INDESIT company

Model type:
AVXXL129EX

Commercial code:
F033725

Notices

n1040398: Programme keys aligned.

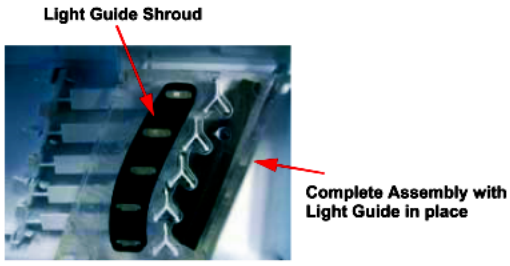
From serial no. 51118.0001, a specially shaped foam pad has been inserted between the keypad and light guide on washing machines AVXXF and AVXXL and washer-dryers AMFFX and AMXXL. The part code of this new component is C00142393 (fig. 001).

This new part separates the keys and pushes them outwards together to ensure they are perfectly aligned.

The pictures in figures 002 and 003 illustrate how the foam pad should be fitted on the keypad and subsequent assembly of the light guide with relative light guide bracket, code C00142648.

The new parts C00142393 and C00142648 can also be used on premodification appliances.

n4008c02: Rear drum replacement

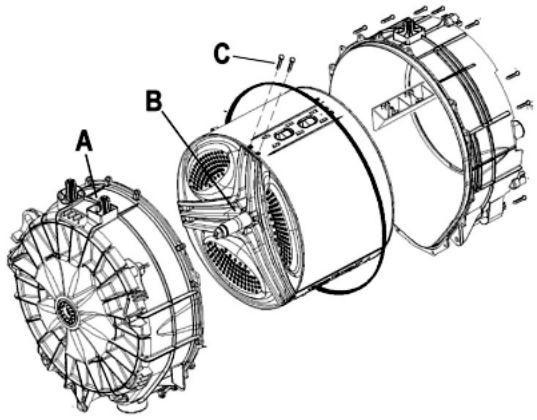
All drum service replacements use 35mm bearings

When you use in assistance the rear drum you will also need to change the drum bearing spider from the 30mm version to the 35mm version

A = C00119357 Drum Rear
B = C00117329 Drum Bearing Spider
C = C00201310 Drum Bearing Spider screws (Qty 6)

Production use 3 screws but for Service we suggest that 6 screws are used.

n0508c01: Door Gasket Clamp Band

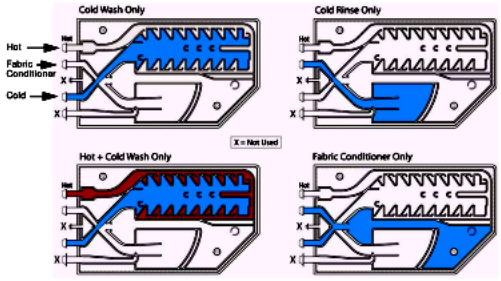
A New Polypropylene Gasket clamp band has been introduced in production from Serial number 80325.0000
The purpose is to provide added support to the inner rim of the door gasket.
